SERVICE BULLETIN #1191

SUBJECT IMPROVING SWITCH BUTTON ACTION

MODEL 1-46, 1-53 DATE 8/31/62

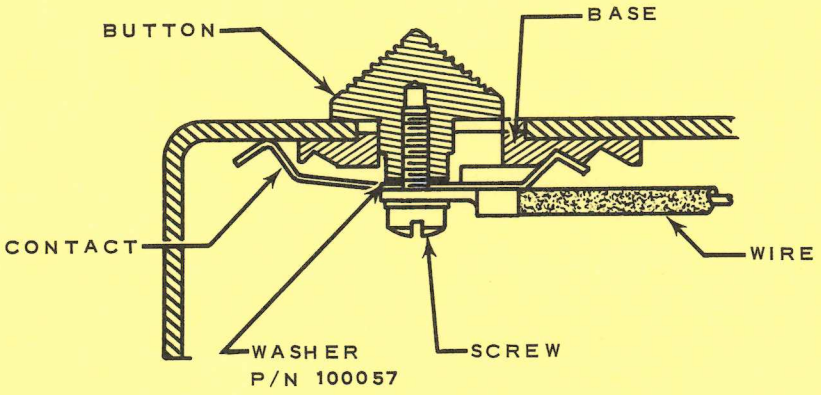
At the top of the fan housing where the ignition switch is mounted on Model 1-46 and 1-53 engines, metal thickness and switch contact spring tension may combine to make the switch button difficult to move. This difficulty has been eliminated on current production models by inserting a Washer, P/N 100057, between the button and the contact.

Chain saws in the field which have this trouble may also be improved by adding the washer. To install it, remove the fan housing, the switch retaining screw, the stop-switch wire assembly, and the switch contact. Leave the switch base and the switch button in place.

As shown in the drawing below, place the Washer, P/N 100057, against the end of the switch button, then replace the switch contact, stop-switch wire assembly, and the retaining screw in the same order in which they were removed. Replace the fan housing.
